OFFICE BUILDING & BASEMENT - FLOOR PLANS - POWER/SYSTEMS

AS-BUILT

PROJECT TITLE
GRANT COUNTY PUBLIC WORKS OFFICE/SHOP COMPLEX
EPHRATA, WA

SHEET TITLE
FLOOR PLAN - OFFICE BUILDING

DATE	03-08-96
DRAWN	SCL
CHECKED	DRW
REVIEWED	DRW
PROJECT NO.	9573 (95184)
DRAWING NO.	E-3

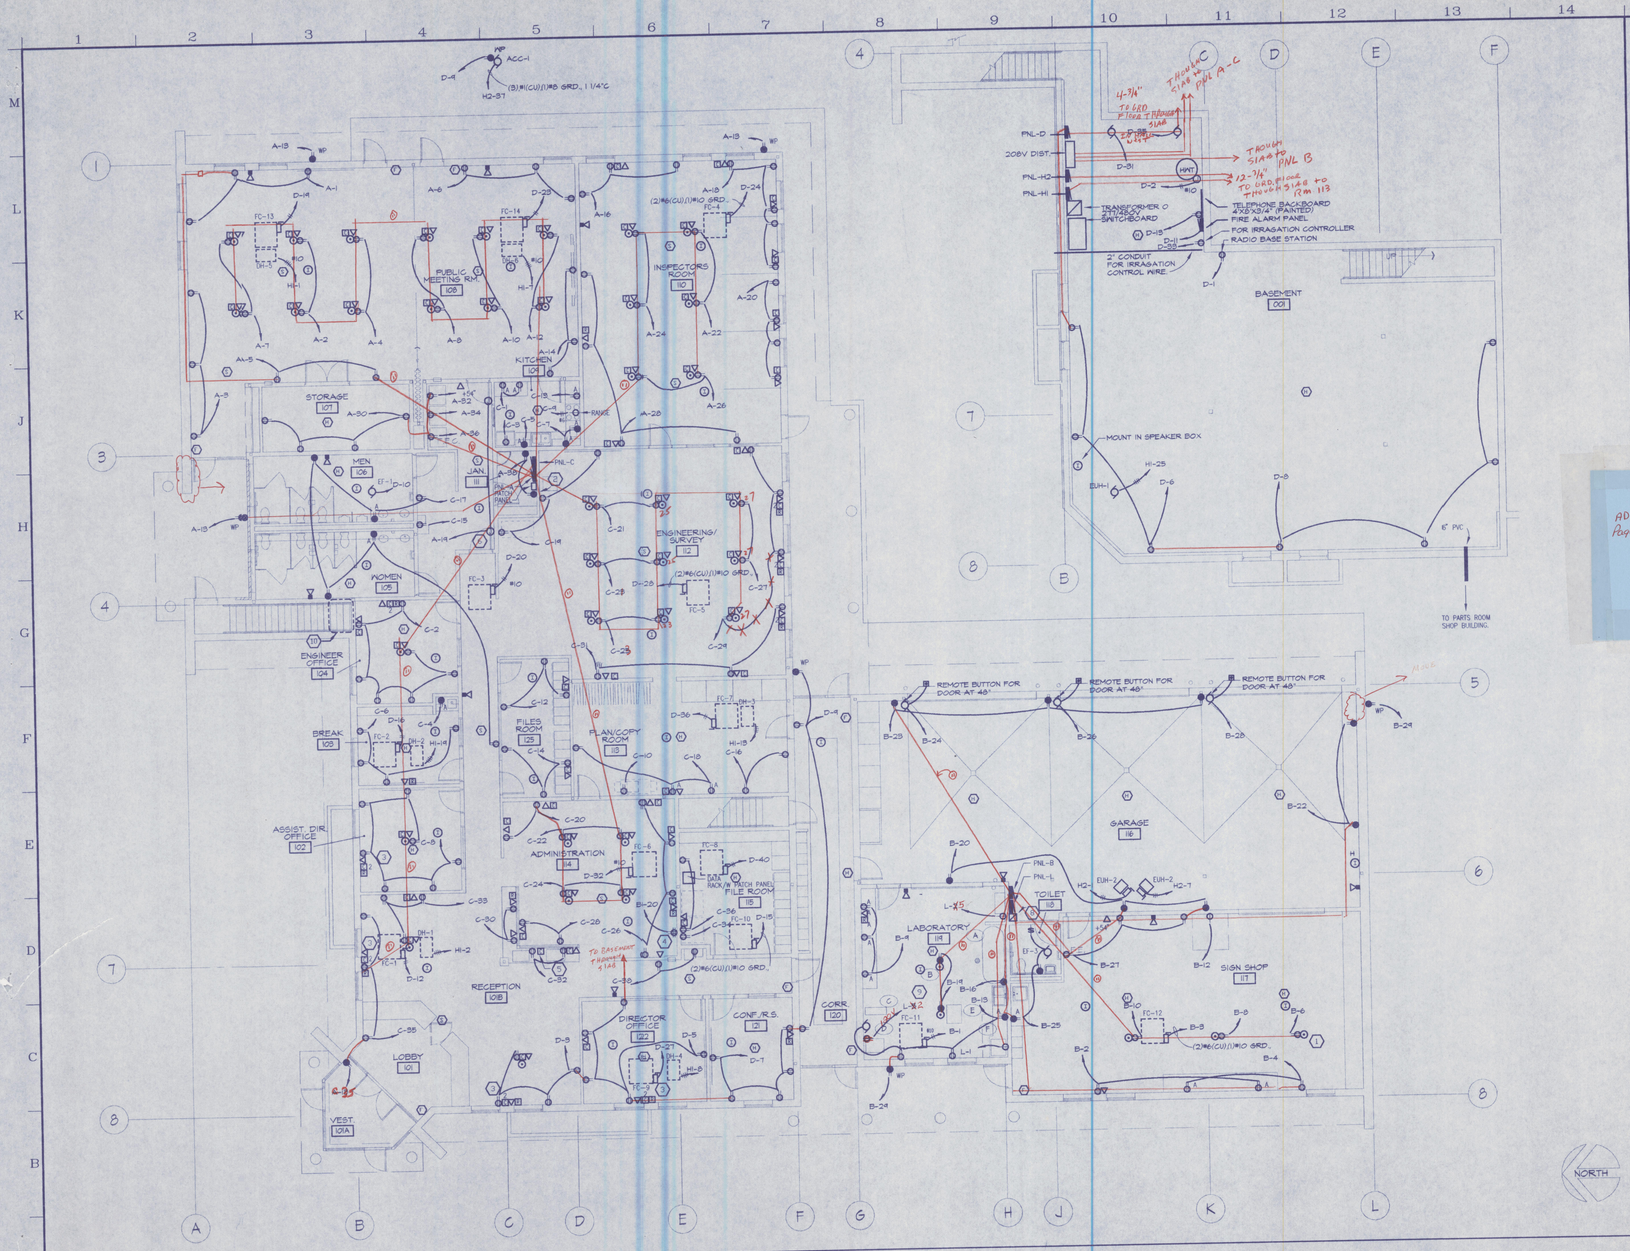
12 Sheet E-3:
. Place fire alarm annunciator panel on north wall east of grid line 3, or as directed by local Fire Marshal.

. Circuit L-2 (testing screen) to be located in the NW corner of room 119 where Circuit L-5 is located. Circuit L-5 (concrete compression tester) is to be located in SE corner of room 119 where Circuit L-2 is shown.

Circuit L-2, testing screen, to terminate in a duplex receptacle. Circuit L-2 to be 120V circuit, not 240V single phase as shown on Panel L schedule.

Provide 3#12 awg cu. and equipment ground in 3/4" conduit to disconnect in SE corner of garage, room 116 for 3 phase 2hp air compressor. Connect air compressor to power according to manufacturer's specifications. Circuit to be B-30.

Room 118 (toilet), fixture to be type 5.
